Gold Standard Verification of  
Afforestation on the Big Island of Hawaii

For  
Hawaiian Legacy Hardwood (HLH) and its affiliates  
Box 22218, Honolulu, HI 96823

December 2020

Report Category:	Afforestation and Reforestation Project
Project ID	GS 3260
Project Name	Afforestation on the Big Island of Hawaii: Restoring Native Hardwood Forests and Enhancing Multiple Ecosystem Services
Project Location	Latitude: 155° 23' 07.98" to 155° 22' 19.73" W Longitude: 19° 58' 16.93" to 19° 56' 40.53" N
Project Owner and address	Hawaiian Legacy Hardwood (HLH), Box 22218, Honolulu, HI 96823
Project Contact	Andrew Callister, Treehouse Consulting
Audit Team Leader	Sunil Kumar Sharma
Audit Team Member	Helen Chandler
Internal Reviewer	Adina Cirtog
Audit Standard:	GS A/R requirements V0.9 (Road Test)
Reporting Period	1 <sup>st</sup> January 2015 to 28 February 2020
Draft Audit Report Issued Date	7 <sup>th</sup> December 2020
Final Audit Report Issued Date	9 <sup>th</sup> December 2020

Figure 1: This map shows the boundaries of the planting area and the eligible planting area where the planting area occurs outside the eligible planting area.

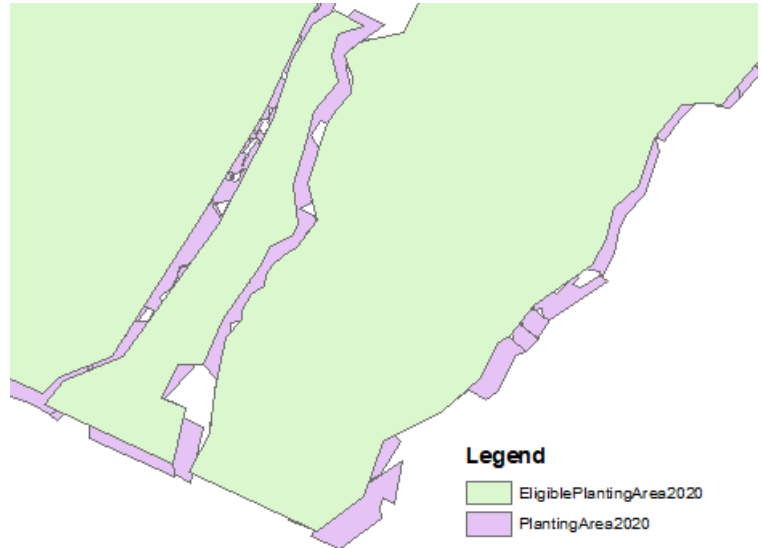
When the eligible planting area map (EligiblePlantingArea2020.shp) was overlaid on the Planting Area Map (PlantingArea2020.shp), the boundary of the planting area occurred outside the eligible planting area. The planting area is part of the eligible planting area and must occur inside the latter's boundary.

Please check and update these maps ensuring the planting area lies inside the eligible planting area.

Please note that this has been addressed in CAR 16/20 also. Planting area (*PlantingArea\_SEPT2020.shp*) lies completely within Eligible Planting Area (*EligiblePlantingArea\_SEPT2020.shp*).

The PO revised the planting area map, eligible planting area map and the project area map. The overlay of the planting area map, eligible planting area map and the project area showed the planting area is located within the EPA and the project area.

Figure 1: Lease area map (*LeaseArea.shp*) with area calculation (The header with PA\_AREA was the area recalculated by the auditor in ArcGIS 10.2)

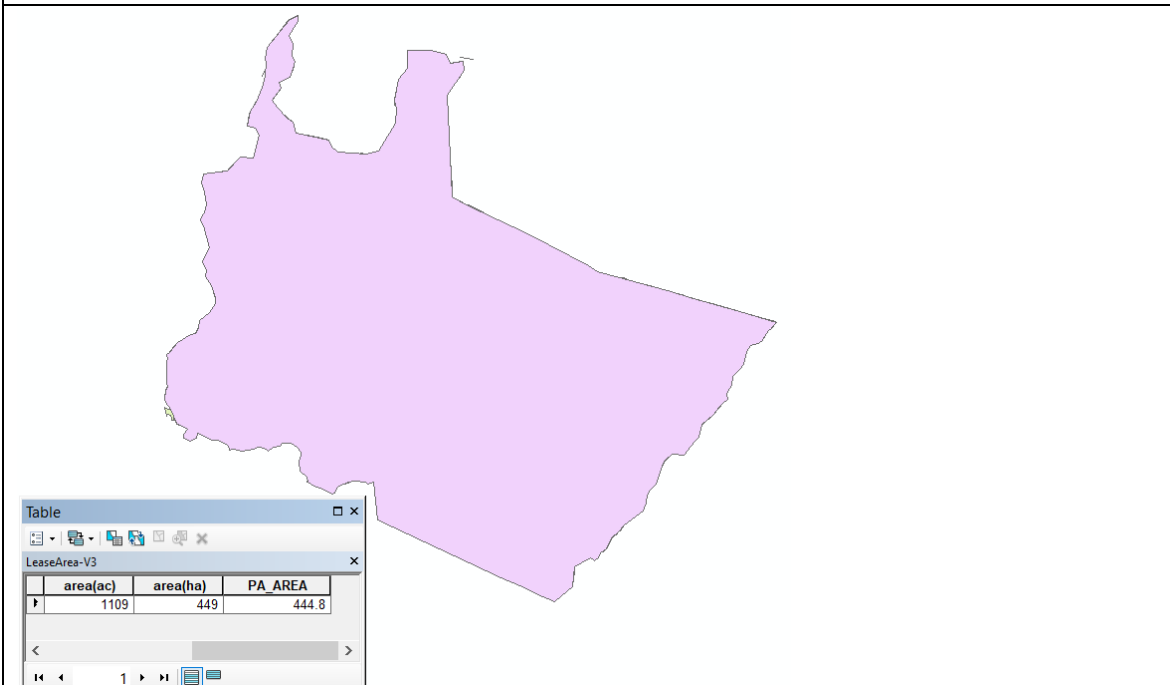
- a) The geospatial dataset *LeaseArea.shp* for the lease area was received with a total area of 449 ha whereas our recalculation of the area using the same file showed a total area of 444.8 ha (see Figure 1). Note that part (e) in the KPI document stated the project area as 485.8 ha and this value does not reconcile with the total area of the leased area.

*amendment 2013.pdf* and to provide a polygon area of exactly 1109.1 acres (448.8 ha).

<i>smallAreas_SEPT2020.shp</i> and associated mapping files <i>GS3260_5.7.10_CO2-Fixation workbook_SEPT2020.xlsx</i>	
Auditor's review of the PO's response:	
<p>a) The PO acknowledged the mistake in the project area previously reported and the issue was not picked up in the validation and verification of the project in 2015. To resolve the issue, the PO supplied a scanned copy of the document 'Second Amendment of Lease' signed on 11<sup>th</sup> Feb 2013 by the Lesser (Kukaiiau Ranch LLC) and the Lessee (Hawaiian Legacy Hardwoods LLC). The lease document had explicitly stated the total lease area of 1109.1 Acres (equivalent to 448.8 ha) and also included maps. The PO digitized the maps in the lease document and generated a lease area map. The Auditor checked the lease map produced by the PO and confirmed the area of 1109 ha. Hence, the issue of the project area and the project boundary have been resolved.</p> <p>b) The PO presented the project area matching the geographical boundary to the lease area map. The project area has now changed to 1109 ha from 1200 ha reported in the initial certification 2015, however, the area was not substantiated by evidence.</p> <p>c) The PO established the eligible planting area of 395.2 ha out of the project area of 448.8 ha after excluding the existing remnant trees, roads and future building sites. The Auditor confirmed that the eligible planting area is completely located within the project area or lease area. Since the project area has been already validated and had initial certification in 2015, the change in the eligible planting area was a mistake carried over due to lack of accurate mapping at the previous validation.</p> <p>d) The planting area map <i>PlantingArea_SEPT2020.shp</i> was imported into the GIS platform and the total area was recalculated. This was confirmed to be 366.6 ha as estimated by the PO.</p> <p>e) The PO also submitted a geospatial file '<i>SmallAreas_SEPT2020.shp</i>' for small areas scattered within the eligible planting area with a total area of 28.38 ha. However, these areas are not included in the planting areas.</p> <p>f) The PO delineated the infrastructure (i.e road network) in the project area with polygon features in the geospatial dataset '<i>Infrastructure_SEPT2020.shp</i>'. The dataset was imported to the GIS platform and recalculated. The road network has a total area of 13.03 ha in the project area.</p>

Figure 2: An overaly of Lease Area, Project Area, Eligible Planting Area and Planting Area

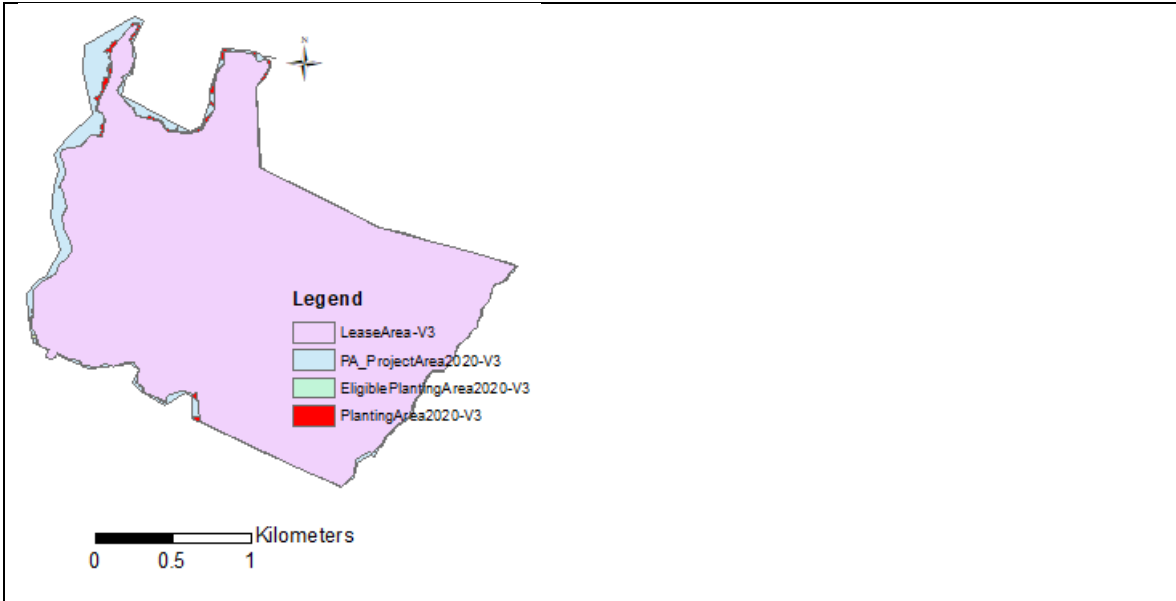
- b) The project area map (*ProjectArea2020.shp*) had a total area of 472.1 ha which exceeds the total area leased for the project implementation (see Figure 2). Since the project is being implemented in the leased area and validated during the project design and the initial certification in 2015, the project area must not change or fall outside the geographic boundary of the leased area in this verification.

- d) The geospatial dataset *PlantingArea2020.shp* showed the geographic boundary of the planting area with a total area of 385.06 ha. The overlay of the planting area, eligible planting area and the lease area shows the boundary of the planting area in the north part exceeded the boundary of the lease area (see Figure 2).

- (b) The shapefile *ProjectArea\_SEPT2020.shp* with supporting files exactly matches the shapefile *LeaseArea\_SEPT2020.shp*. Project activities have not been conducted outside this area, and the Project Area has not changed in the field even though its extent has been variously reported in the historical documentation.
- (c) The present calculation of Eligible Planting Area is 395.2 ha, and this is considered the best estimate. It has been derived from shapefile *EligiblePlantingArea\_SEPT2020.shp* and is reported in Item (e) of *GS3260\_2.1\_Key Project Information\_SEPT2020.pdf*.

Figure 3: Eligible Planting Area map (EligiblePlantingArea2020.shp) with area calculation (The header with PA\_AREA was the area recalculated by the auditor in ArcGIS 10.2)

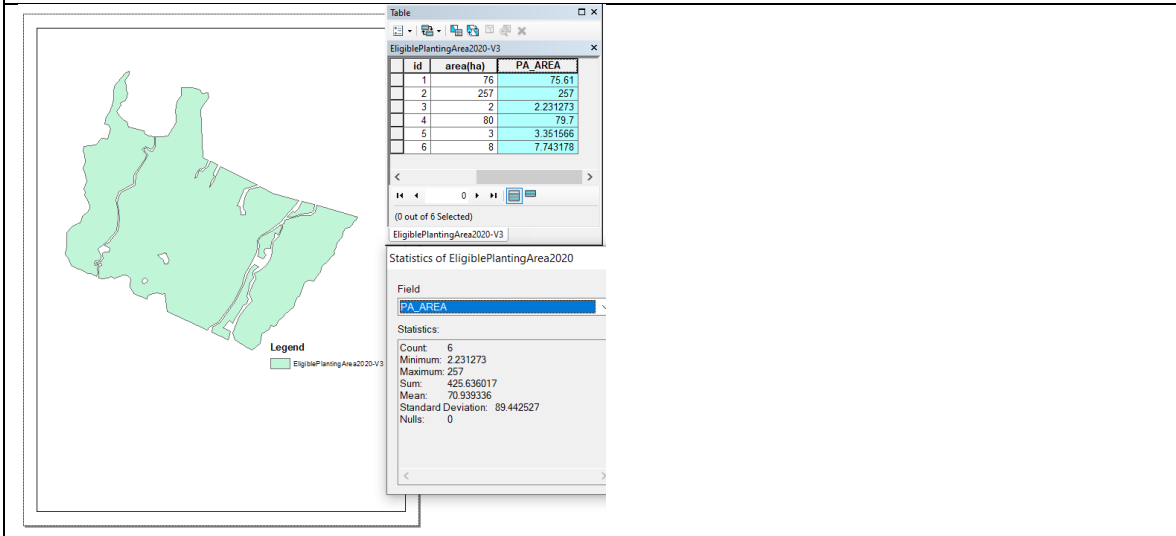
- c) The geospatial dataset *EligiblePlantingArea2020.shp* presented the geographic boundary of the eligible planting area which meets the applicability conditions for implementing the project activity with a total area of 428 ha. The auditor recalculated the area to 425.63 ha (see Figure 3). We noted that the eligible planting area was estimated as 336.7 ha in the initial certification and 384.6 ha in the KPI document submitted for this verification.

- (g) Please confirm that the project area is located within the lease area and has not changed since the initial certification in 2015.
- (h) The eligible planting area which meets the applicability conditions shall not change after the project design validation and initial verification. Please clarify why the eligible planting area is being changed in the KPI document in the initial certification (i.e. 336.7 ha) and the KPI document in this verification (384.6 ha) and in the geospatial dataset, *EligiblePlantingArea2020.shp* (425.63 ha).

The present calculation of Eligible Planting Area excludes only remnant or pre-existing vegetation (shown in *RemVeg\_SEPT2020.shp*), road infrastructure (shown as polygon areas in *Infrastructure\_SEPT2020.shp*), and small areas reserved from planting as potential future building sites (shown in *FutureBuilding\_SEPT2020.shp*) from the Project Area. Great effort was taken to digitise these excluded layers precisely, including the mapping of each individual pre-existing koa tree.

- (d) The planting area of 366.6 ha (see Cell C28 in sheet *MU Summary\_Project* of *GS3260\_5.7.10\_CO2-Fixation workbook\_SEPT2020.xlsx*) is shown in shapefile *PlantingArea\_SEPT2020.shp*. It is calculated by adding the MU areas of all planted and proposed future modelling units. 28.4 ha of small polygon areas are intended to remain unplanted due to the inefficiency of filling them in. These are mapped in *smallAreas\_SEPT2020.shp*. Note that this shapefile layer is not exactly precise as it is used primarily for HLH internal planning purposes and there are roughly 0.2 ha of very small polygons included in Eligible Planting Area but not in Planting Area or Small Area shapefile layers.

Figure 4: An overlay of Lease Area, Eligible Planting Area and Infrastructure map

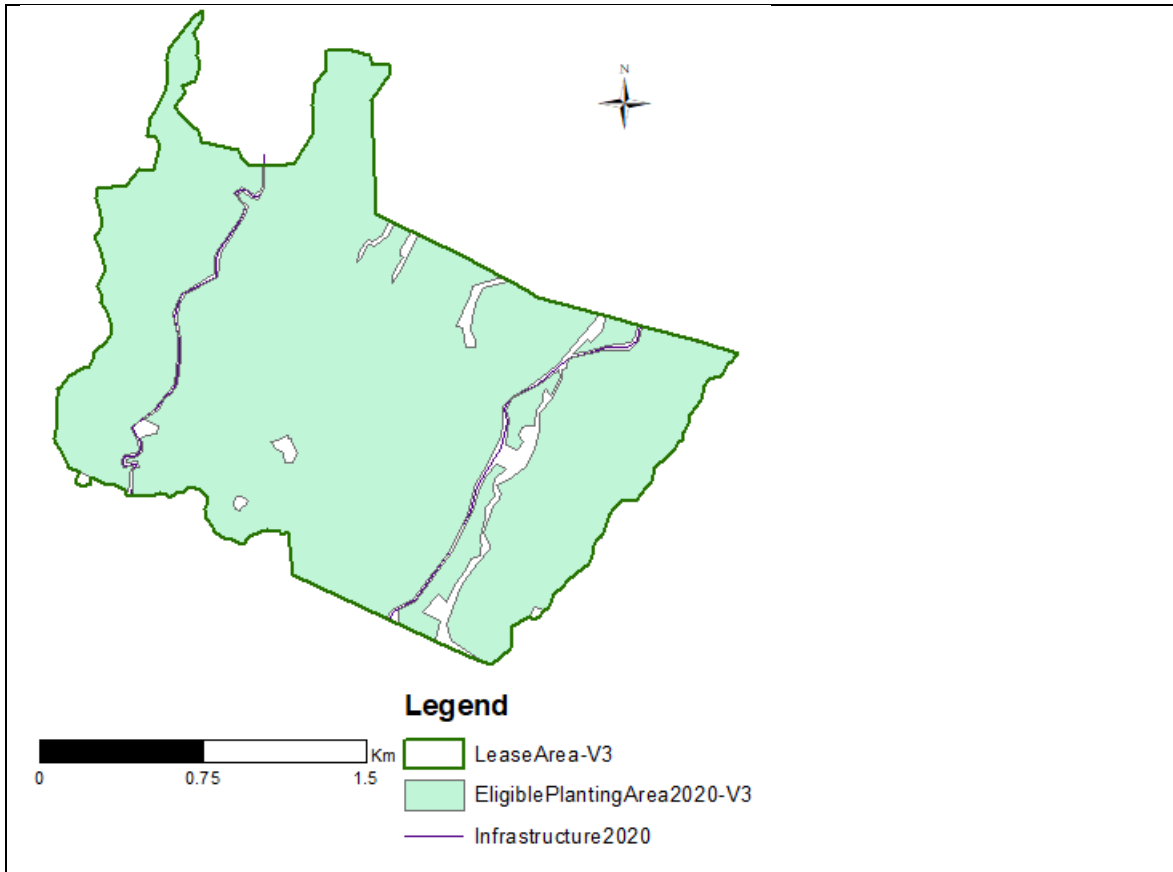
- e) The geospatial dataset for eligible planting area (*EligiblePlantingArea2020.shp*) showed some areas where the project activity could not be implemented. Although the geospatial dataset *Infrastructure2020.shp* was included in the audit pack, this file did not show the area, but rather (poly)lines, hence, did not match the areas excluded in the eligible planting area map (Figure 4). We also noted that the eligible planting area had more area excluded where the project activity could not be implemented.

- (i) Please confirm that the planting area is located within the lease area and has not changed since the initial certification in 2015.
- (j) Please update the geospatial dataset for infrastructure matching to the areas shown in the *EligiblePlantingArea2020.shp*.

Figure 5: Reference to the spatial reference missing notification for the satellite imageries submitted

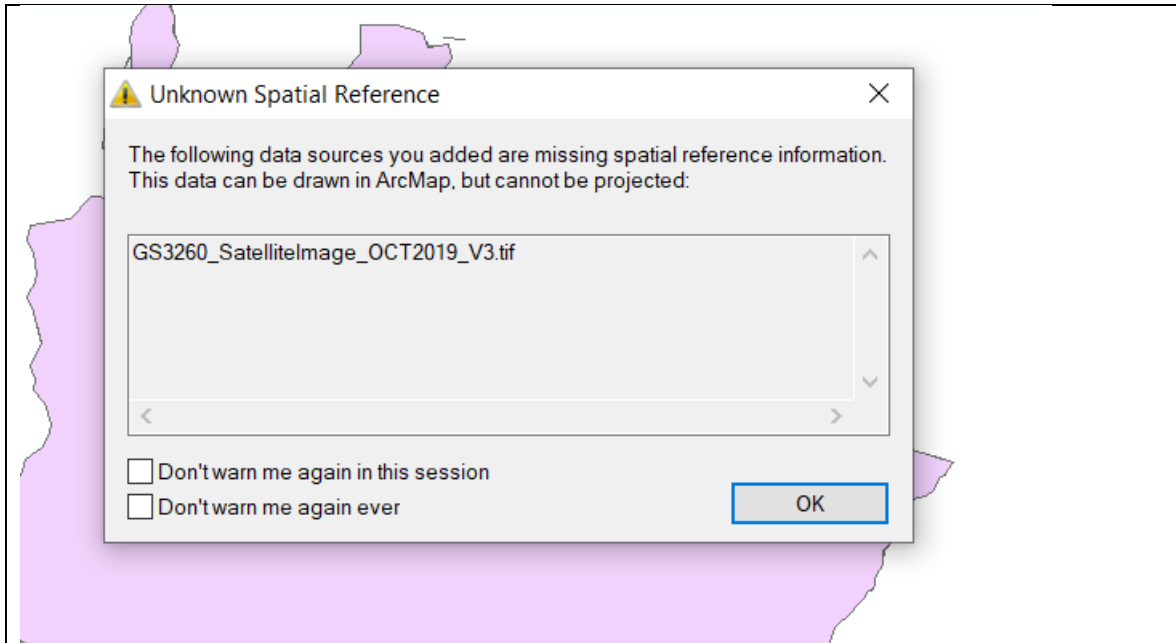
CAR #:	CAR 17/20
Occurrence in the Document(s)	<i>GS3260_SatelliteImage_OCT2019_V3.tif</i>
Reference:	GS A/R v0.9; Chapter 2. Key Project Information Requirements
Description of an issue to be addressed:	
<p>We acknowledge the receipt of high resolution imageries (<i>GS3260_SatelliteImage_OCT2019_V3.tif</i> and <i>2004_HLH_ProjectArea_V2.tif</i>). However, these datasets are lacking spatial reference and could not be displayed together with other geospatial datasets of the project.</p>

- a) The PO is requested to project these imageries with the same spatial reference and projection as the other geospatial datasets of the project so that the imageries can be overlaid with the project maps.
- b) Please provide the sources of these imageries and the date they were taken.

Figure 2: Overlay of MU 16-L on EPA map demonstrates the MU 16-L is entirely located within the Project Area boundary.

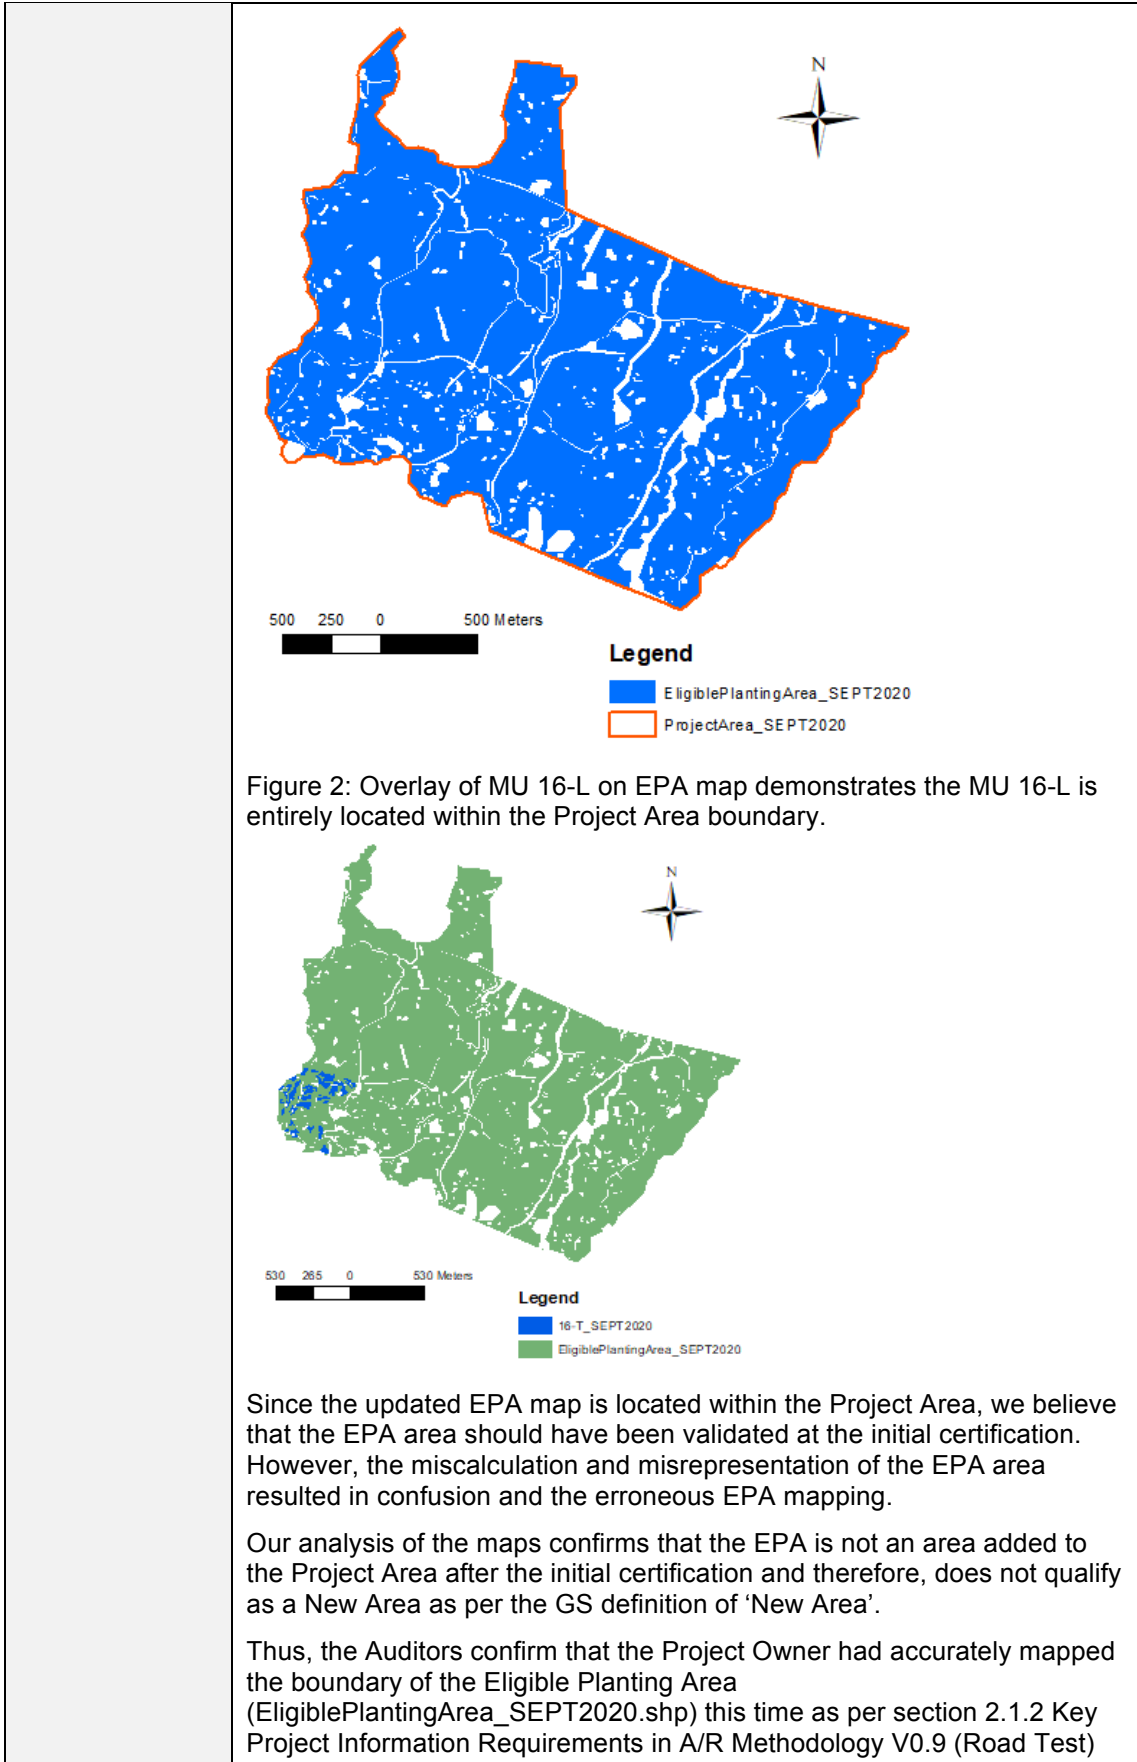
Risk Area 4	The Project has not extended the Eligible Project Area outside the Project Area.	
Audit Findings	<p>CAR 04/20 raised an issue regarding the change in the eligible planting area from 336.7 ha in the initial certification to 384.6 ha in this verification. The PO acknowledged this issue and clarified that the EPA mapping was not accurately done previously and the area quoted in the initial certification mistakenly did not include MU 16-T area of 42.6 ha. We received two EPA maps with different areas and ground representation. 2015EligiblePlantingArea.shp had 376.6 ha while another EMA map ((c) Eligible Planting Area.shp) had 420 ha. Following the update of the Lease Area and Project Area maps conforming to the lease area boundary as per the lease agreement, the PO prepared a new EPA map (EligiblePlantingArea_SEPT2020.shp) excluding the infrastructure, remnant vegetation, small areas and future building area. An analysis in ArcGIS 10.2 confirms that the EPA map excludes the non-eligible area of 53.1 ha (i.e. summation of infrastructure, remnant vegetation, small areas and future building area) from the Project Area of 448.8 ha and the area calculation gives the same result as the area of the EPA map (395.7 ha). Further we checked and confirmed by overlaying the maps that the EPA lies within the Project Area boundary (Figure 1) and MU 16-L, missed in the calculation, is located within the EPA. (Figure 2).</p> <p>Figure 1: Overlay of the EPA map on the Project Area map demonstrates the EAP area is entirely located within the Project Area boundary.</p>

Since the updated EPA map is located within the Project Area, we believe that the EPA area should have been validated at the initial certification. However, the miscalculation and misrepresentation of the EPA area resulted in confusion and the erroneous EPA mapping.

Our analysis of the maps confirms that the EPA is not an area added to the Project Area after the initial certification and therefore, does not qualify as a New Area as per the GS definition of 'New Area'.
